ZP-24-29; 323-325 College Street (RH, Ward 8) 323 Green Castle, LLC / Alpha Properties, LLC / Benjamin Frye

TO: Development Review Board
FROM: Garret King
DATE: March 6th, 2023
RE: ZP-24-29; 323-325 College Street

Request: Reapplication of ZP-22-416 for the proposed construction of a 4-unit building addition with associated utility work and minor grading.

A2

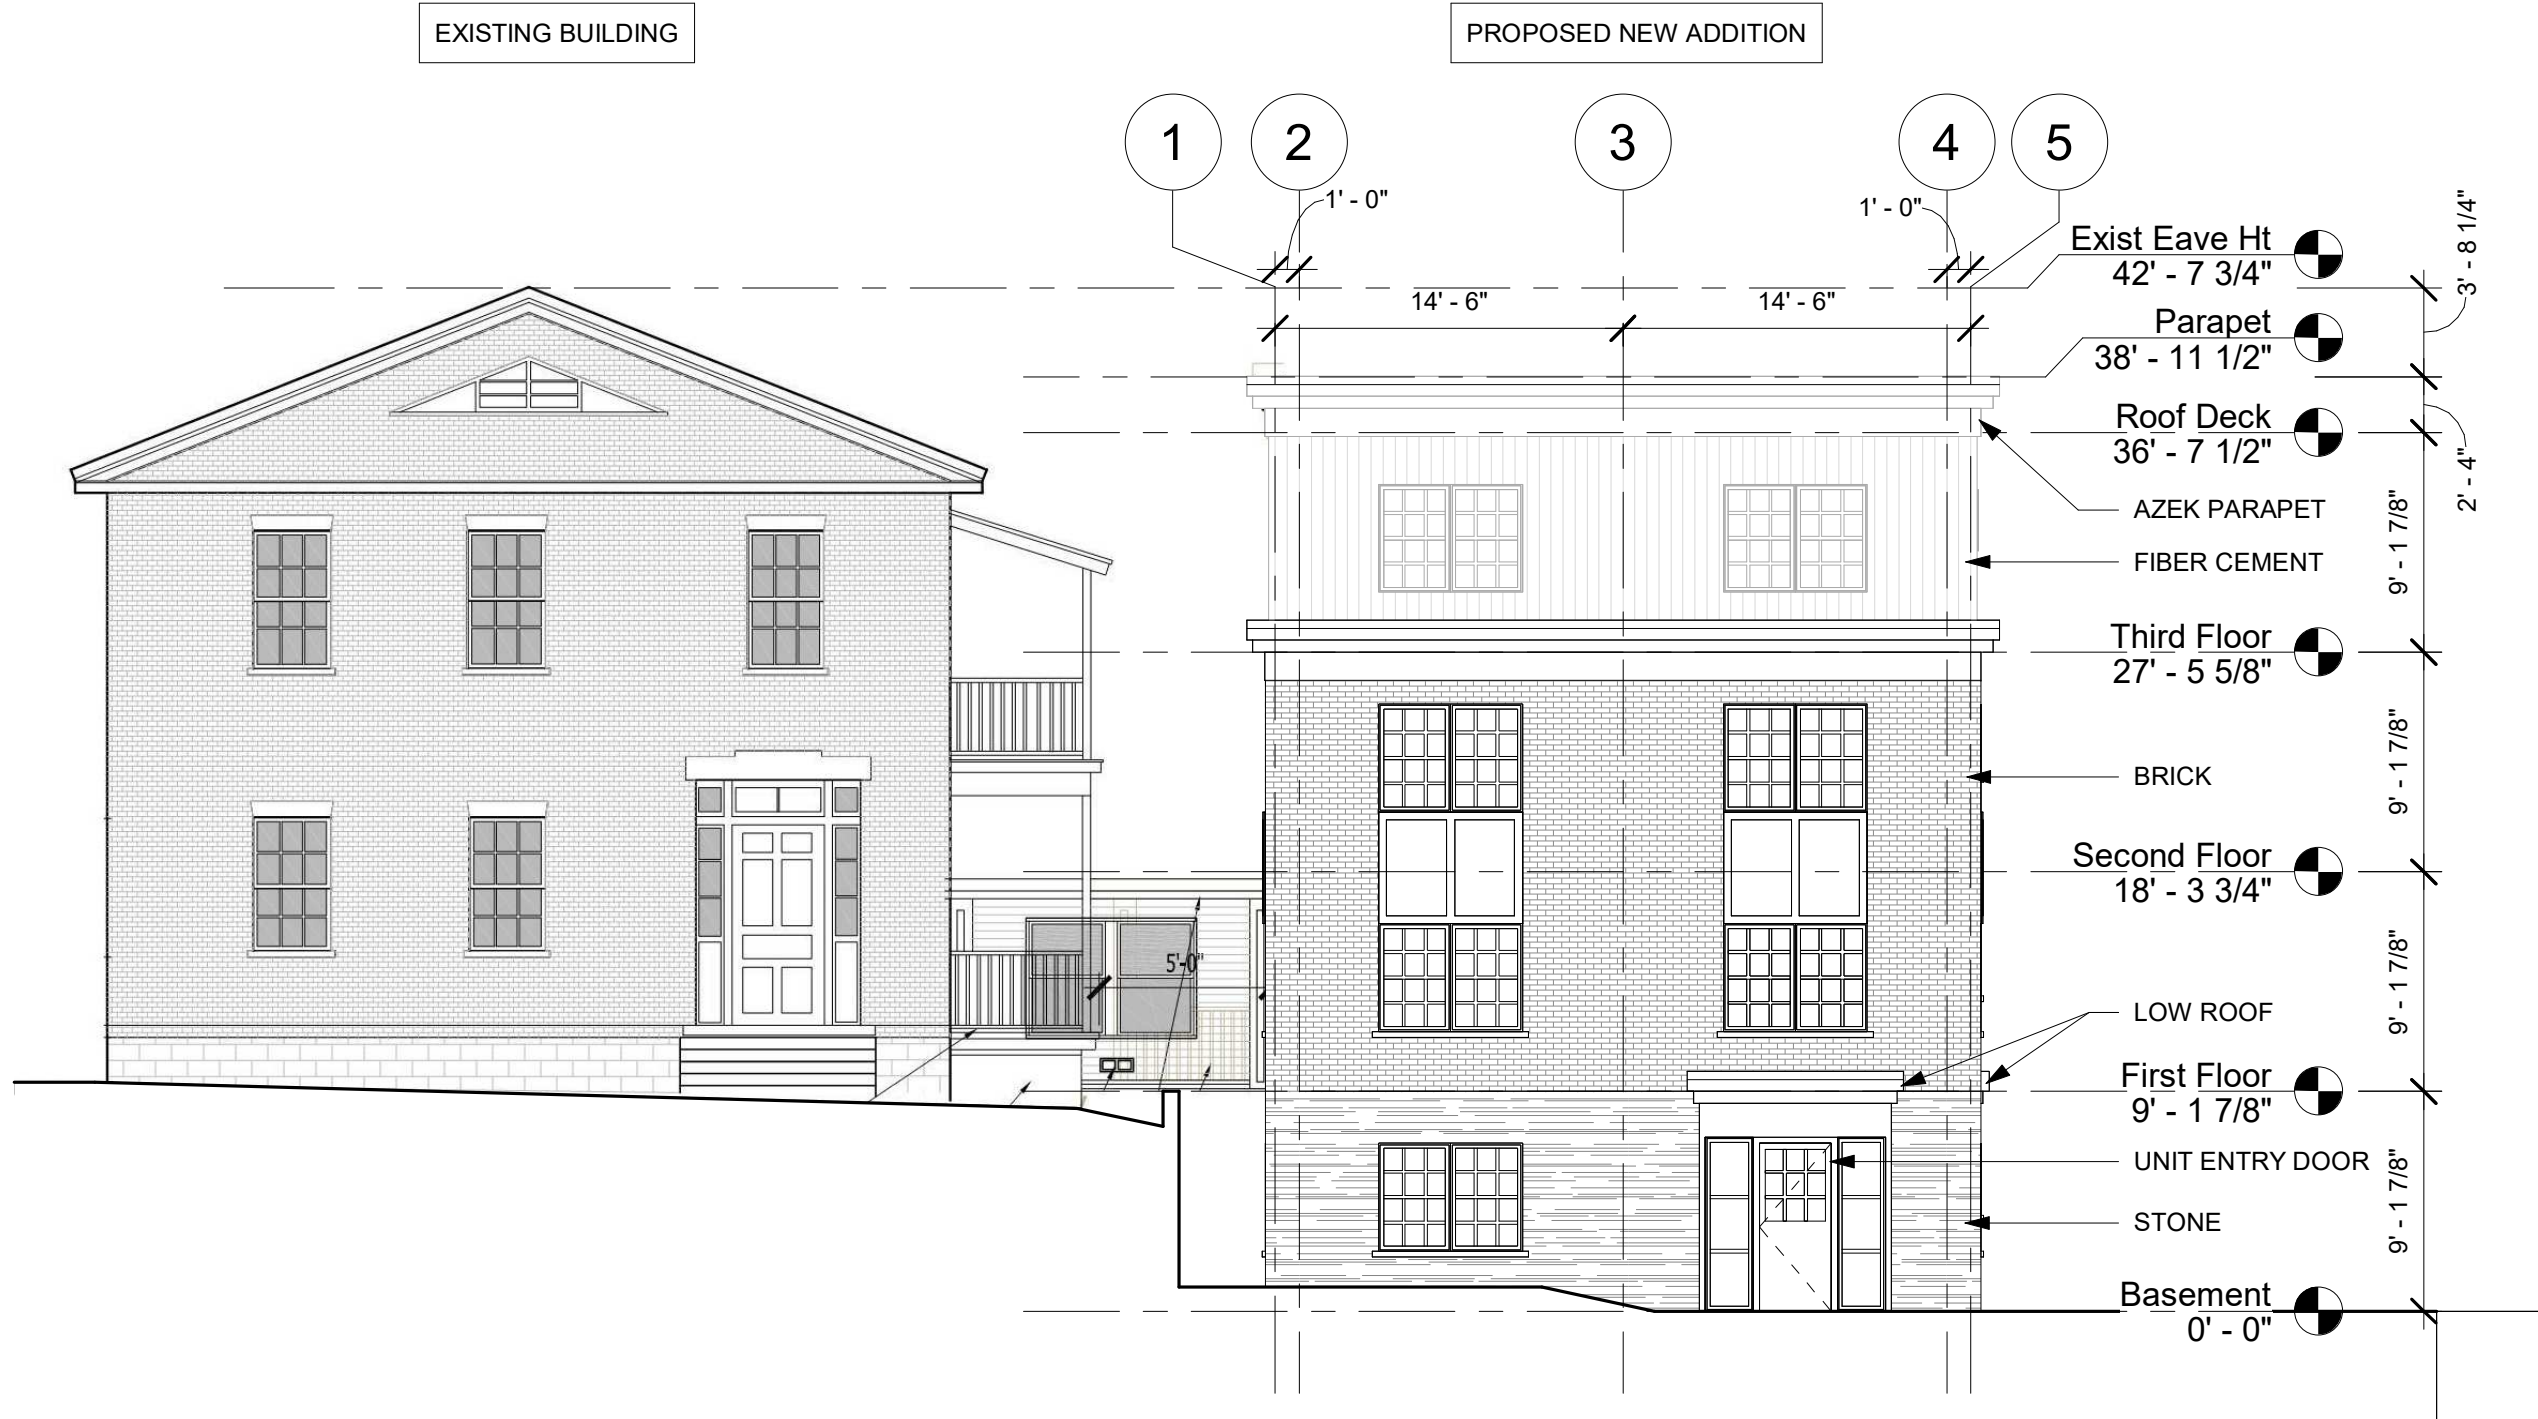
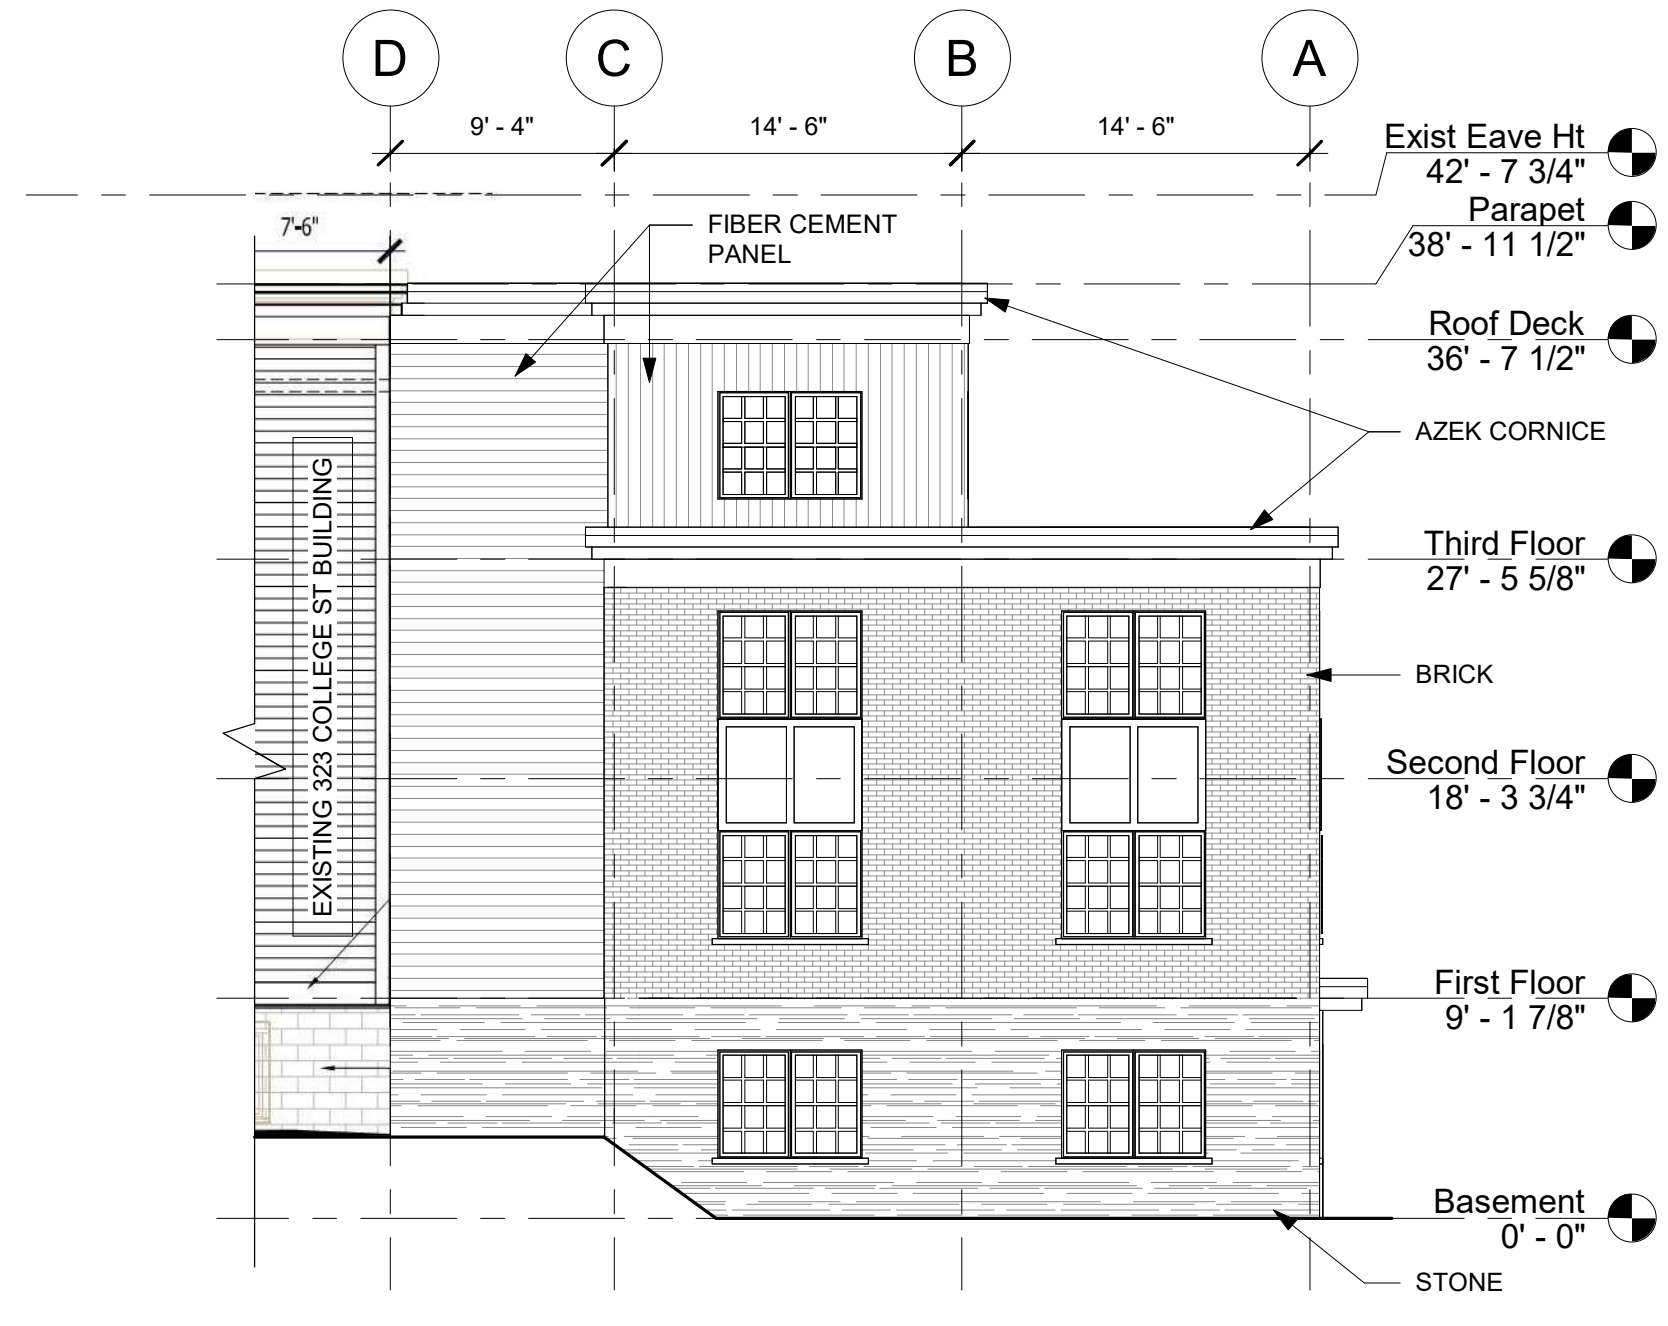
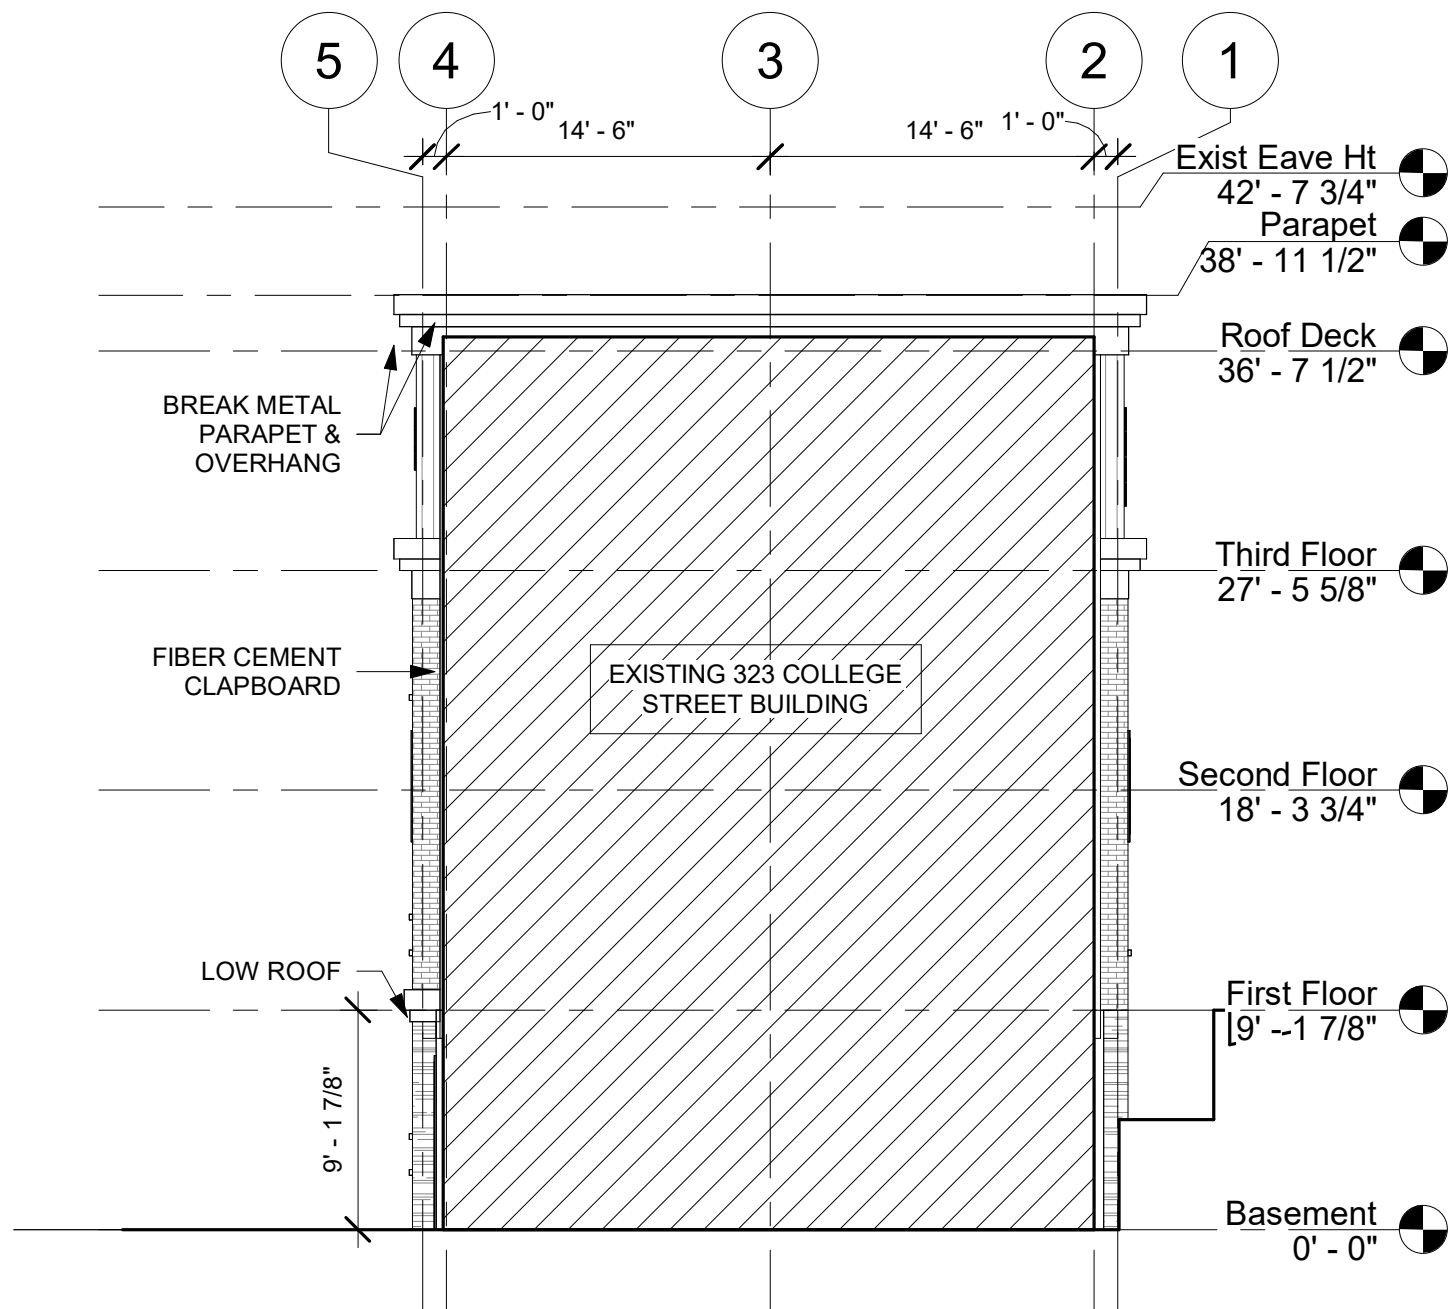
Doors are illustrated on both the north and west elevations (Plan A2), each of which include a canopy above. The applicant provided a snow management plan with previous applications, which remains the same and involves trucking snow off-site. **Affirmative finding as conditioned.**
